Re: Response to Comments for LOMR for Brickhouse Gully;
City of Houston
Brickhouse Gully (E115-00-00)

Below are our responses to the third HCFCF courtesy review comments to the LOMR for Brickhouse Gully dated April 4, 2014.

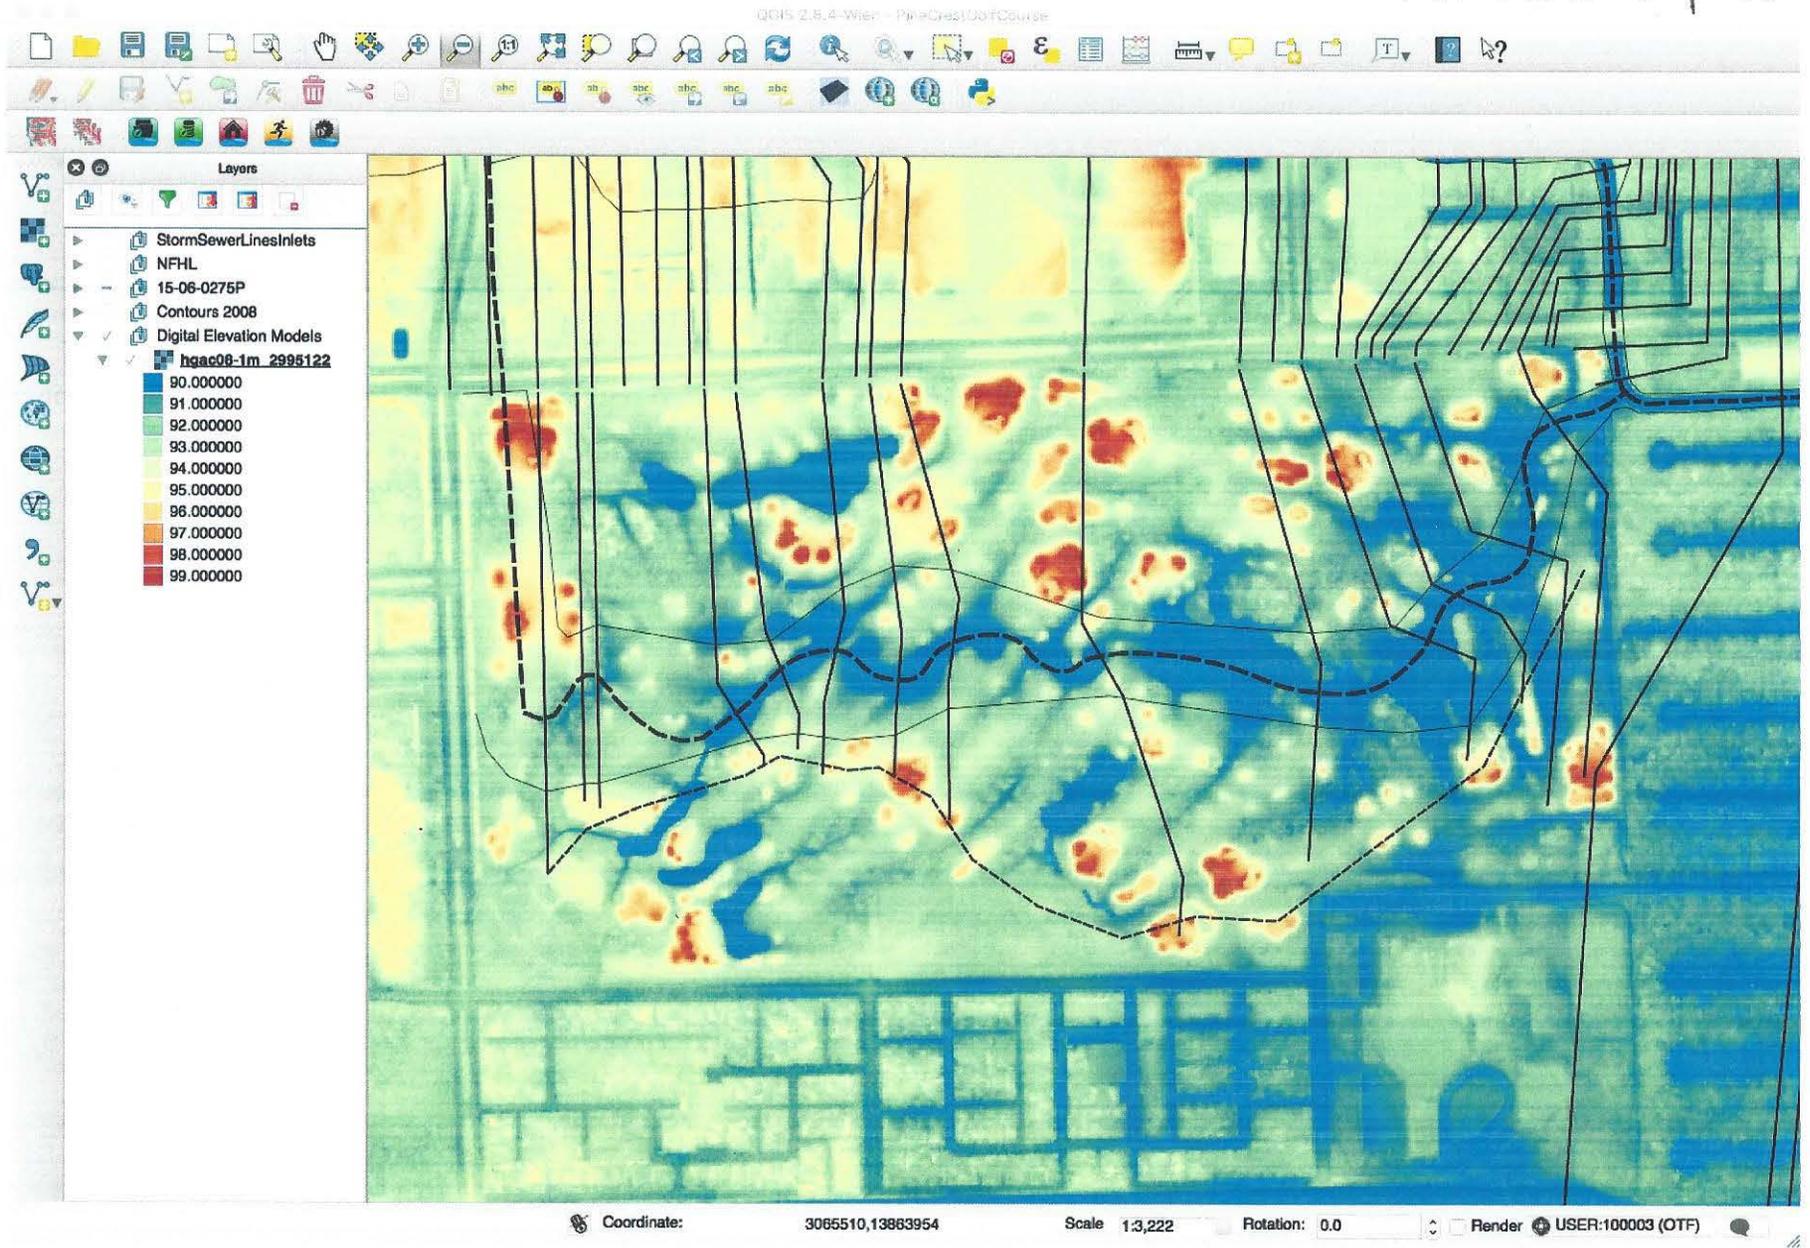
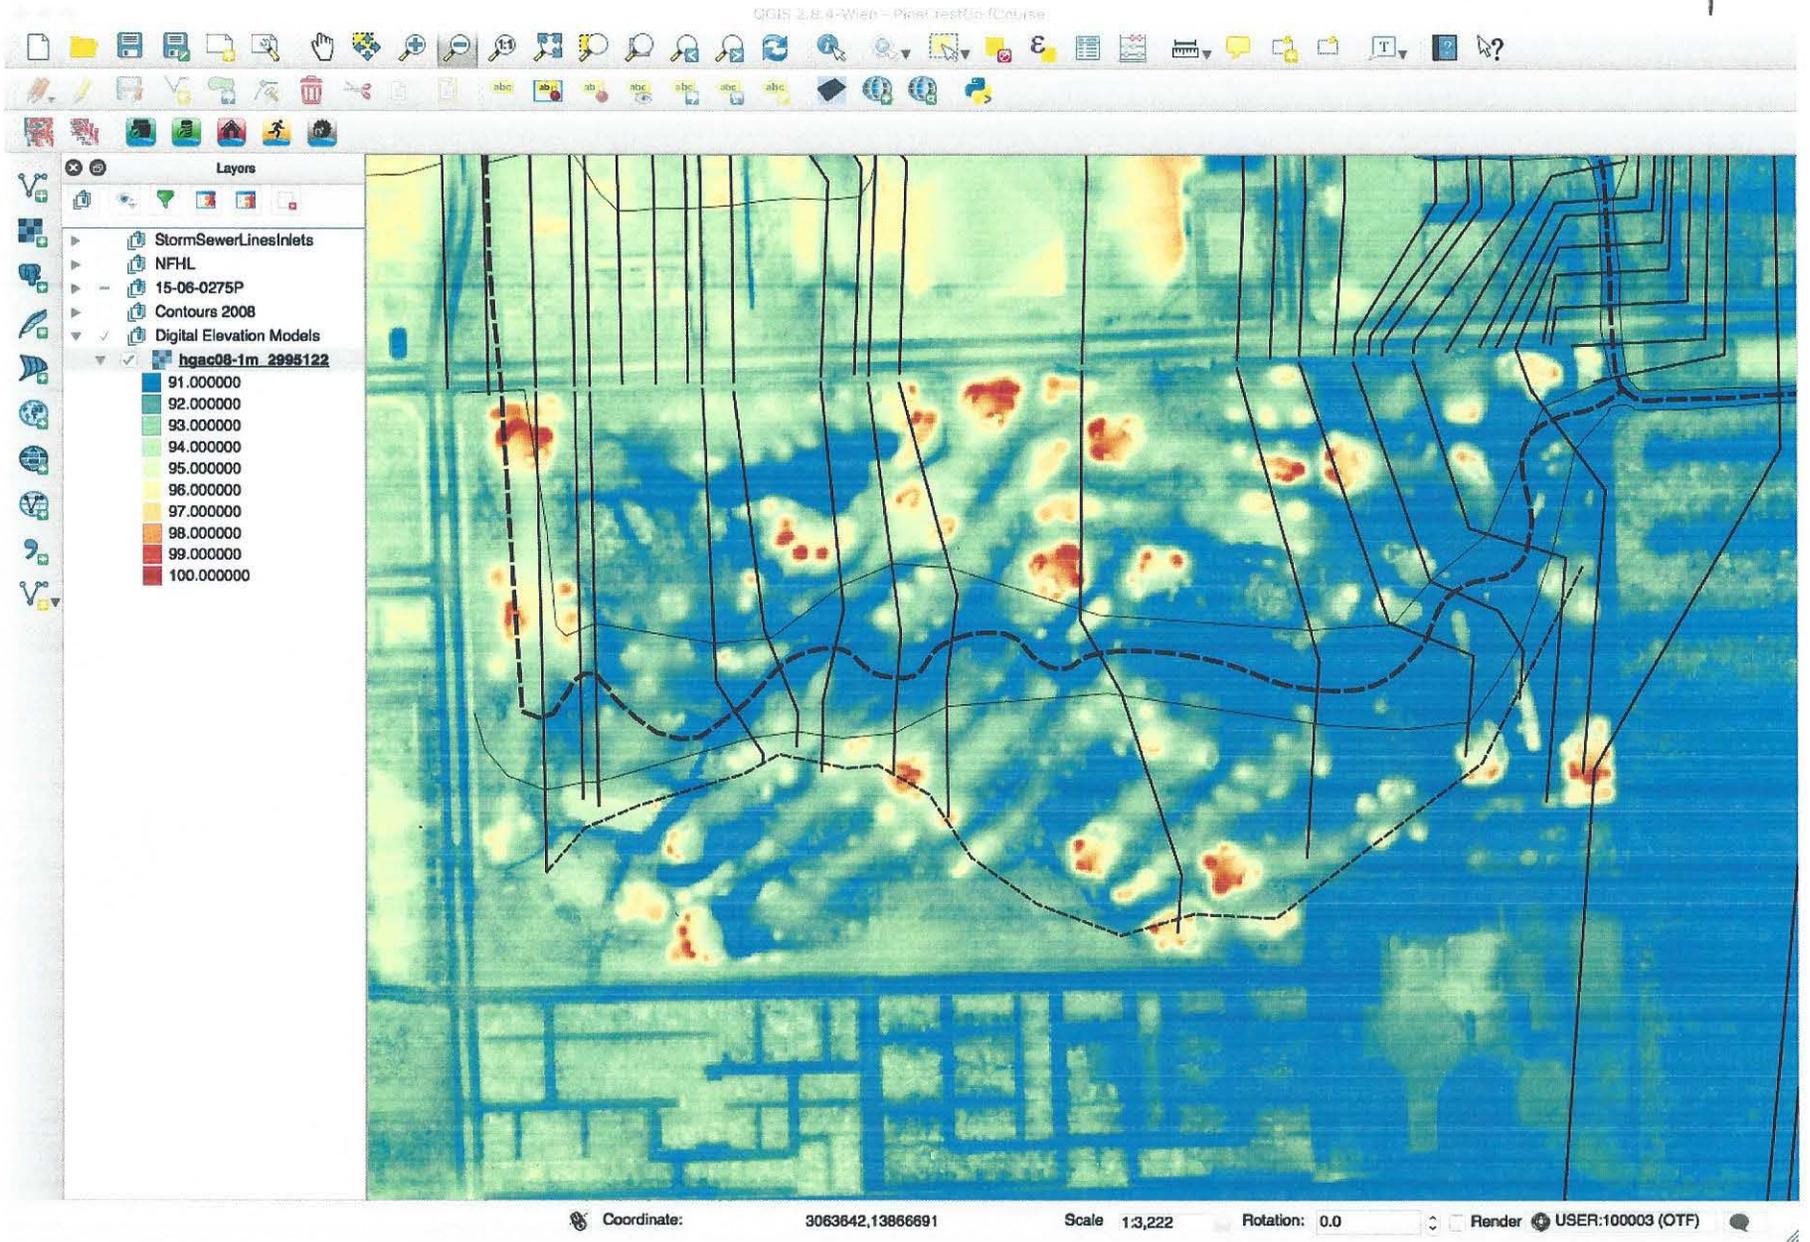
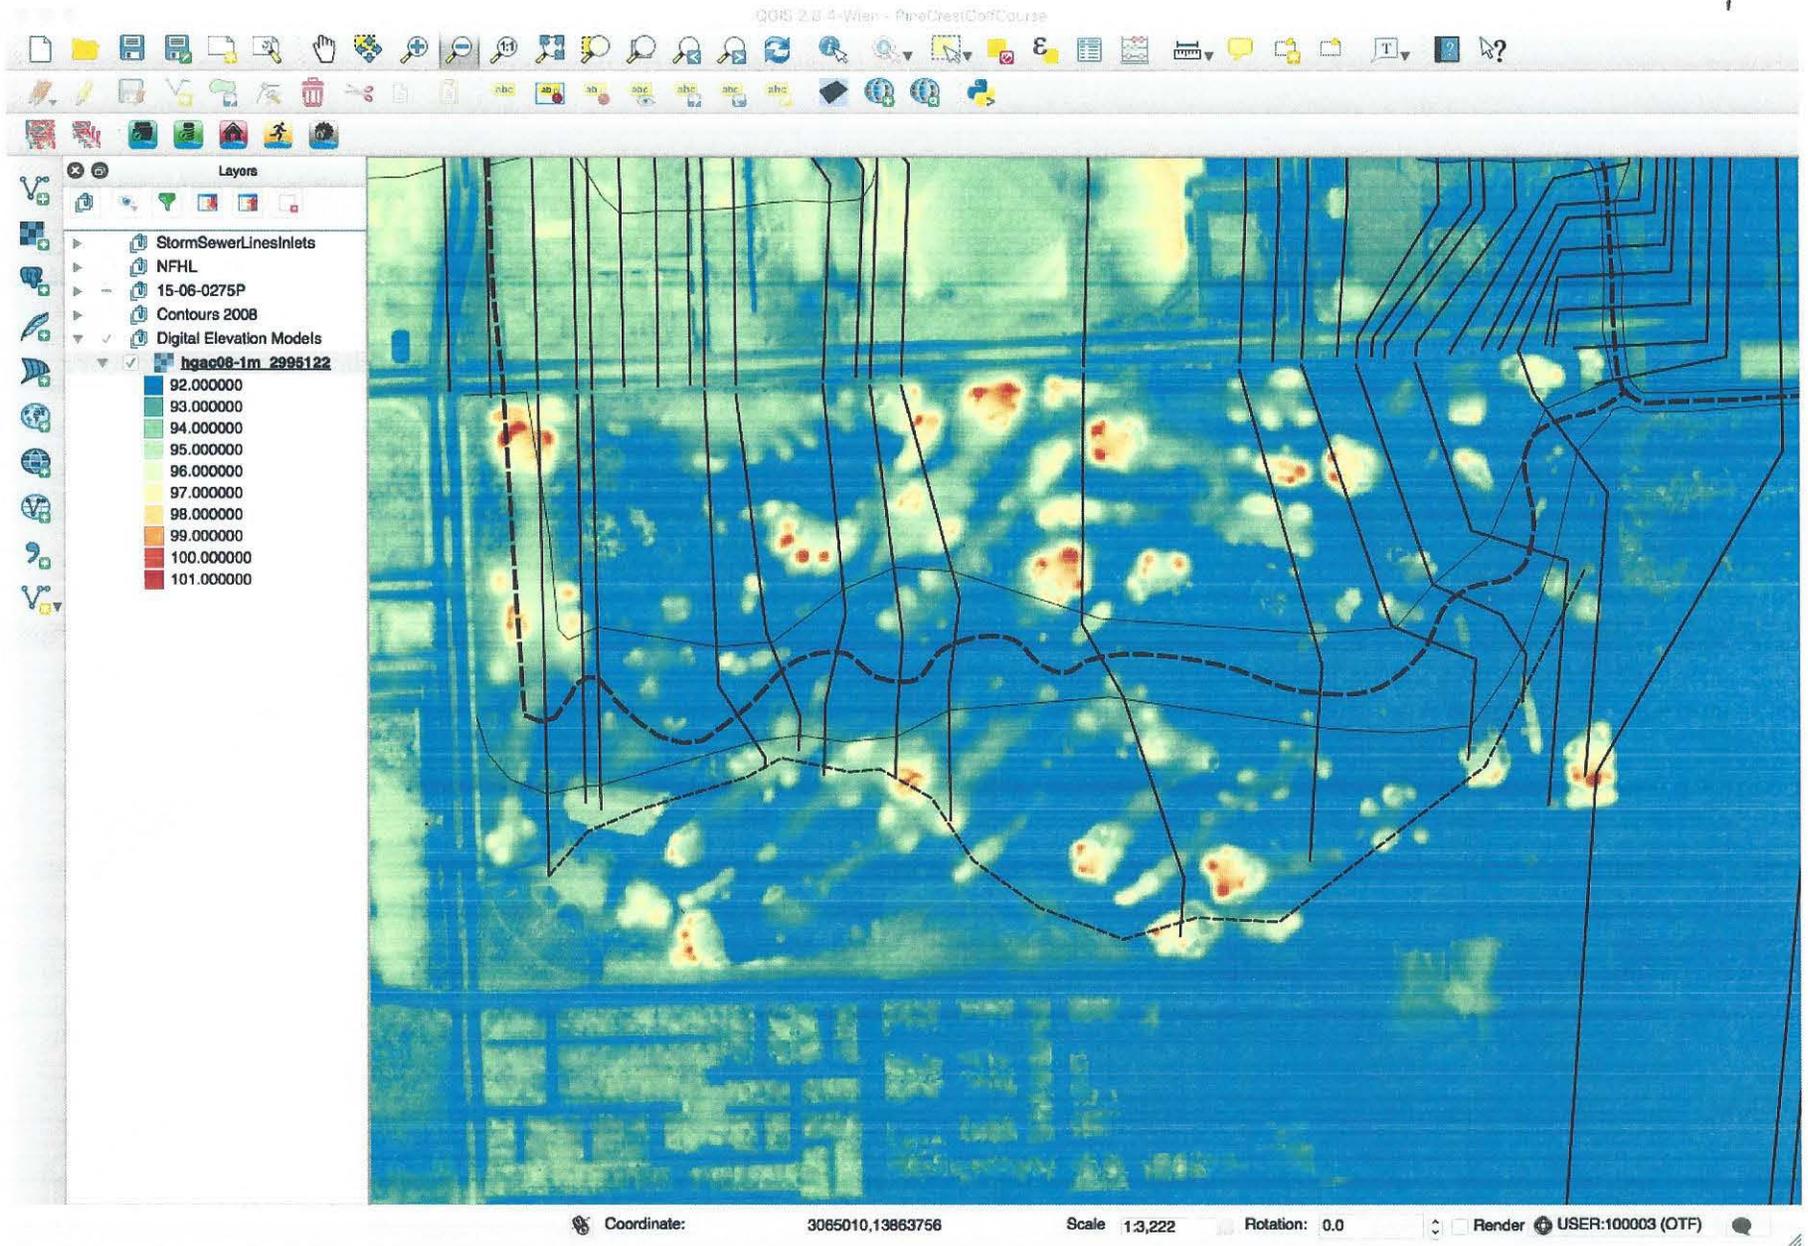
Inundation at 90 feet. The proposed channel and ridge would not hold water.

Inundation at 91 feet. The proposed channel and ridge would not hold water.

Inundation at 92 feet. The proposed channel and ridge would not hold water.

Pine Crest Golf Course – Dynamic Flood Depths at Base Flood Event (100 Year Flood)

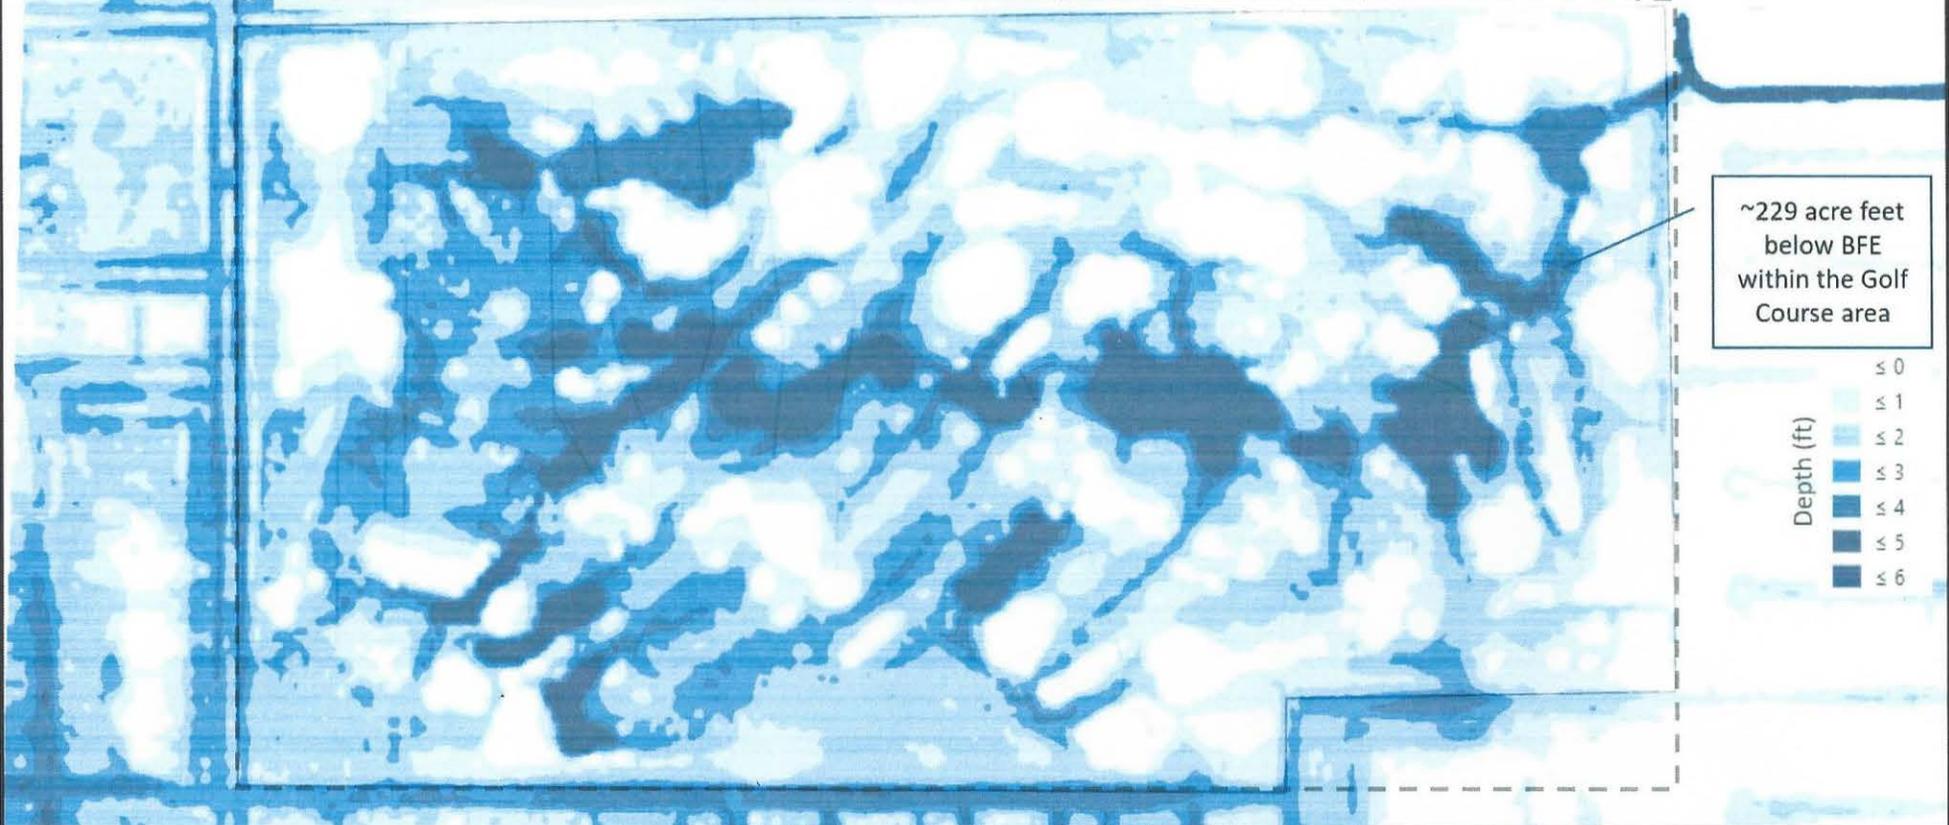
This highly-sculpted, golf course property accommodated approximately 229 acre feet of floodwater volume during a 100 year flood event. The developers are bringing in fill dirt, elevating the property and saving approximately 86 acre feet of detention volume. That leaves 143 acre feet of flood water volume which cannot be detained on the property. The surrounding properties will be forced to accommodate this extra flood water during the next 100 year flood event.

In addition, the new housing development will cover a high percentage of the area with impervious surface. This surface is not offset with any detention volume (as required in Fort Bend County), further increasing the flood risk to local residents.
